APPLICATION NO.	FILING DATE	FIRST NAMED INVENTOR	ATTORNEY DOCKET NO.	CONFIRMATION NO.
09/867,709	05/31/2001	Young-jin Song	Q64254	6220

Office Action Summary

DETAILED ACTION

FIG. 1

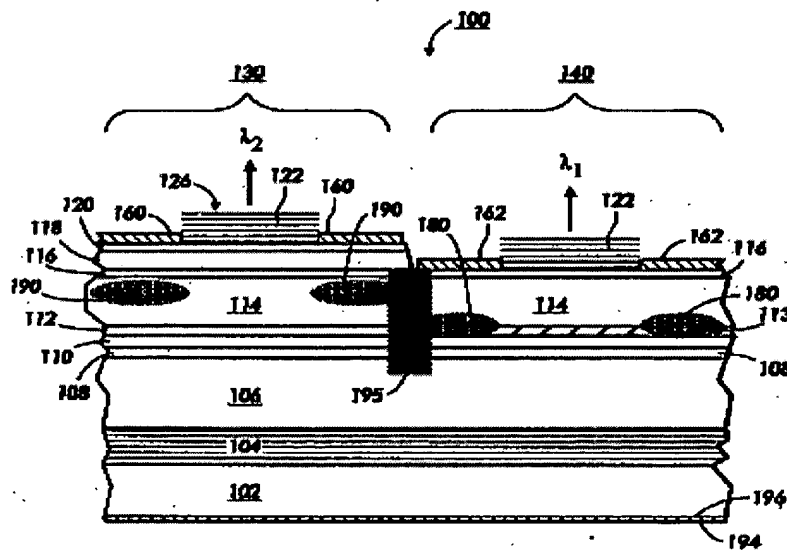
Claims 1 rejected under 35 U.S.C. 102(b) as being anticipated by Paoli (PN 5,699,375).

Figure 1 illustrates a multiple wavelength laser system having plural laser units with a substrate (102), a DBR (104) having alternating layers which provide reflection, an active region (108), an intermediate region (114), top contact layers (160,162) and a top DBR with alternating layers which provide reflection.

²⁻¹²
Claims ~~3, 4, 8 and 10~~ are rejected under 35 U.S.C. 103(a) as being unpatentable over Paoli (PN 5,699,375) in view of Coman et al (PN 6,320,206).

Figure 1 of Paoli illustrates a multiple wavelength laser system having plural laser units with a substrate (102), a DBR (104) having alternating layers which provide reflection, an active region (108), an intermediate region (114), top contact layers (160,162) and a top DBR with alternating layers which provide reflection.

Paoli does not disclose using the particular dielectric alternating materials as claimed in the invention.

Coman et al discloses in column 4 lines 9-15 that such materials as silicon dioxide, titanium oxide and zirconium oxide are used in DBR alternating layers to provide a low index of refraction and a high index of refraction layers.

Therefore, it would have been obvious to a person having ordinary skill in the art at the time the invention was made to use any of the known dielectric materials to form DBR of alternating layers within the semiconductor lasers.
